VERMONT YANKEE NUCLEAR POWER CORPORATION

**Subject: Vermont Yankee Nuclear Power Station
License No. DPR-28 (Docket No. 50-271)
Response to Request For Additional Information Concerning VY-IPEEE**

Vermont Yankee Nuclear Power Station
Individual Plant Examination External Events (IPEEE)
Response to NRC Request for Additional Information
(December 1999)

Figure FIRE-3-1 MANUAL SUPPRESSION FAILURE PROBABILITY DISTRIBUTION

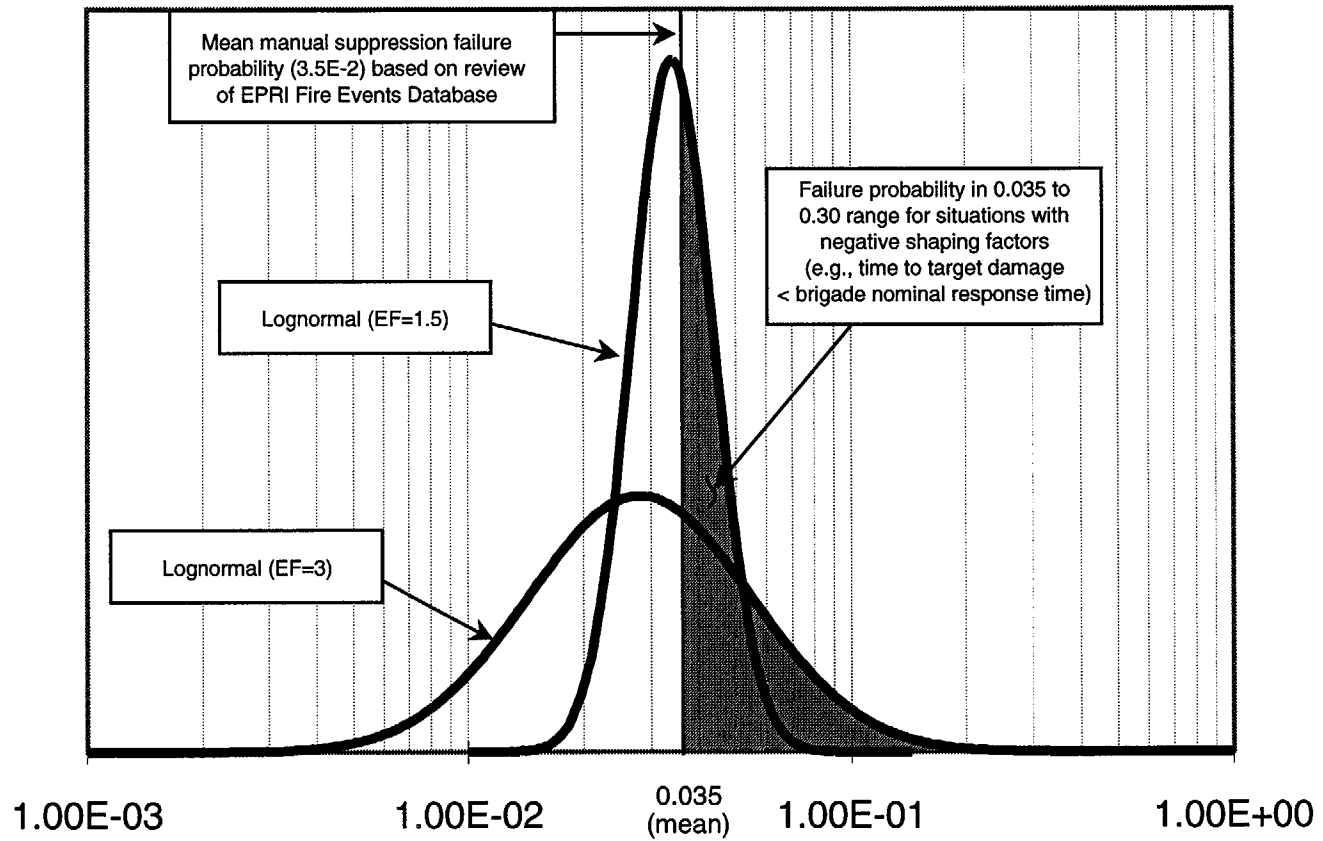
There are a number of points related to the analysis of the Reactor Building Cable Separation Zone (CSZ) that require clarification. First, the treatment of manual suppression appears optimistic. A 90% manual suppression reliability appears to have been assumed (a manual non-suppression probability of 0.1 is cited). A fire brigade initial response time of ten minutes was estimated for this zone; however, the initial brigade response time should not be equated to the fire suppression time. Suppression time must include the time needed to detect the fire, verify the fire, assemble and equip the fire fighting team, assess the fire situation, and actively suppress the fire. Further, manual suppression reliability should consider the time to fire damage as compared to the time required for suppression. In the study a damage time of 12.5 minutes is cited for damage to cable tray Division S1 and Division S2. Given an initial brigade response time of 10 minutes (after detection), it would appear highly optimistic to assume a 90% manual suppression reliability before damage occurs. Secondly, the bases of the fire ignition frequencies, including any severity or correction factors, used for this zone were not described. This aspect of the analysis may also be impacted by the concerns discussed in RAI number 2 above. Third, the dependence between failure of the automatic system and failure of manual fire fighting support systems (e.g., hose stream standpipes) was not discussed. For example, if the fire water supply to the sprinkler system fails, then it would appear likely that the water supply to manual hose stream might also fail. Fourth, the compartment is cited as being covered by a partial pre-action sprinkler system. It is not clear what coverage this system provides, how this system was credited in the analysis, or how its effectiveness against the postulated fire scenarios was assessed. Finally, it is not clear what systems are potentially impacted by fire in this area.

For the Reactor Building CSZ, please discuss in more detail the fire protection features of this area including a description of the fire detection system, fixed fire suppression system, and systems needed to support manual fire fighting activities. Describe how the effectiveness of the fixed suppression system was assessed and credited in the analysis. Discuss the time required for fire detection and verification, initial fire brigade response, assembling and equipping the brigade, fire situation assessment, and actual fire suppression for the postulated fires in this zone. Identify the plant systems and equipment located in this area and discuss their importance to plant safety. Describe the fire scenarios postulated for this area, including the bases for the assumed fire ignition frequencies associated with each fire scenario and consideration of concerns identified in RAI number 2 above. Also discuss the conditional core damage probability (CCDP) for loss of all equipment in the room for each of the postulated fire scenarios. Discuss the estimated time(s) to critical component damage that have been assumed in the analysis and their bases. Provide an explicit justification for the assumed manual suppression reliability estimate used in the analysis or repeat the analysis for the CSZ using more realistic manual non-suppression probabilities. Assess the potential for dependence between failure of automatic suppression and failure of manual fire fighting support systems. Given the above factors, reassess the CDF contribution of this compartment.

Fire brigade failure is defined as failure to prevent fire spread beyond the initial fuel source such that equipment damage occurs beyond the initial fuel source. The failure probability for manual suppression is assumed to be 0.1, which is consistent with the FIVE methodology. Interviews with plant fire protection and training personnel suggest that a reasonable response time is approximately 10 minutes for the Cable Separation Zone. VY believes that a manual suppression failure probability of 0.1 is reasonable based on the following discussion.

As discussed in Section 4.8 of the VY IPEEE Submittal, review of the EPRI fire events database results in a manual suppression failure probability of approximately 0.03 - 0.04. In this second approach the industry generic experience is used to assess the effectiveness of the fire brigade function (analogous to calculating offsite power recovery failure based on industry events). Review of the EPRI Fire Events Database (FEDB) first identified those events involving brigade response, then the data fields for the ignition source and for components effected by the fire were compared. Depending upon various data interpretations (e.g., Was the fire already extinguished by automatic suppression systems prior to fire brigade arrival?; Was adjacent equipment indeed impacted?), the failure probability is estimated between 0.03 and 0.04.

The FEDB review approach inherently takes into account the realistic nature and the spectrum of fires, such as, they involve various combustion efficiencies and various heat release rate profiles. Using $3.5E-2$ as the mean value and applying a lognormal distribution (refer to Figure FIRE-3-1) shows that the brigade failure probability is in the $2E-2$ to $3E-1$ range. Detrimental shaping factors (e.g., brigade nominal response time equal to or greater than the estimated time to target damage) would place the value at the higher end of the range; non-detrimental shaping factors (e.g., brigade nominal response time much less than the estimated time to target damage) would place the value at the middle to lower end of the range.

Figure: Flood - 2 - 1

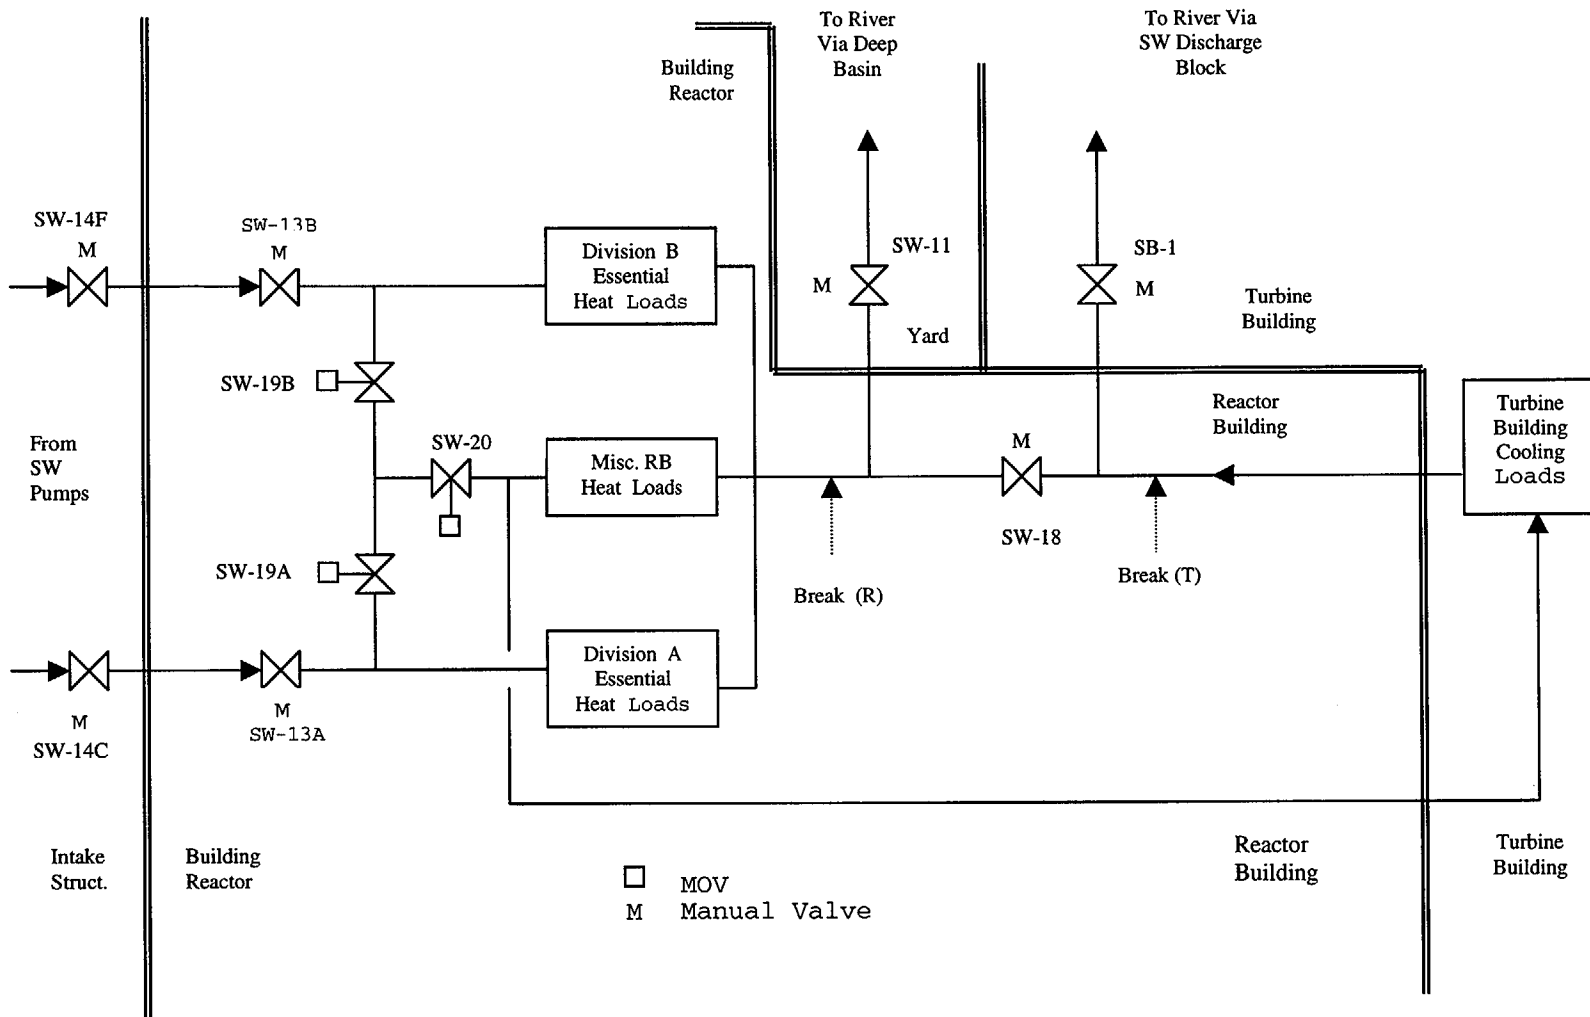
The internal flooding associated with "RBTRF2: un-isolable service water return line break in reactor building," yielded a CDF of about 6E-06, which is about 70% of the total internal flooding CDF. Section 7.2.3 of the submittal states that it has been proposed to evaluate hardware and procedural modifications (not credited); however, it is not explained what exactly these improvements are. Since this is the most risk significant initiator, it is reasonable to expect a more focused emphasis in terms of improvements in this particular area. Please explain if any specific improvements have been identified and have been, or are planned to be, implemented.

Initiator RBTRF2 evaluates a postulated major pipe break in the Service Water system discharge header located in the Reactor Building. The discharge header at this location is common to SW headers A and B in the Reactor Building. SW discharge flow from the Turbine Building also connects to this discharge pipe located in the Torus room (refer to Figure Flood-2-1).

Break Isolation and SW Restoration: The current PRA model of initiator RBTRF2 assumes that a break located in the Reactor Building SW discharge line is guaranteed to fail the SW system heat removal function. The assumption of failing all SW is the reason this event is referred to as un-isolable. Recovery of the SW function is not credited in the current PRA model. Flooding Figure 2-1 provides a simplified piping schematic of the common SW discharge pipe in the Reactor Building. One concept being investigated for training and enhanced procedures includes the possible isolation and restoration of SW depending on the break location as described below. Crediting restoration of the SW function upon isolation of the break will reduce the CDF of the RBTRF2 event. However, detailed investigations may identify other solutions that are feasible from a PRA perspective.
